* 242/15 - CARTAS NÁUTICAS DO INSTITUTO HIDROGRÁFICO –
CN 25R08 – Correções

Na CN 25R08, proceder às seguintes correções (WGS 84):

CN 25R08

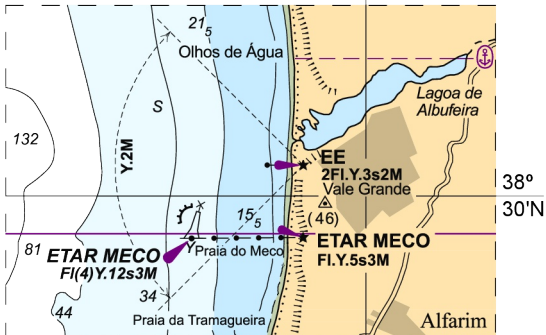
Inserir cabo submarino, , unindo:

38°34,00'N / 009°13,47'W;
38°31,49'N / 009°26,43'W;
38°31,29'N / 009°28,22'W;
38°30,94'N / 009°29,64'W;
38°30,79'N / 009°30,69'W;
38°30,00'N / 009°32,51'W;
38°28,31'N / 009°34,00'W;

área de cabos submarinos    , unindo:

38°34,00'N / 009°15,11'W;
38°31,59'N / 009°28,23'W;
38°30,98'N / 009°28,23'W;
38°34,00'N / 009°11,52'W.

por colagem o anexo gráfico contido na Secção VIII.
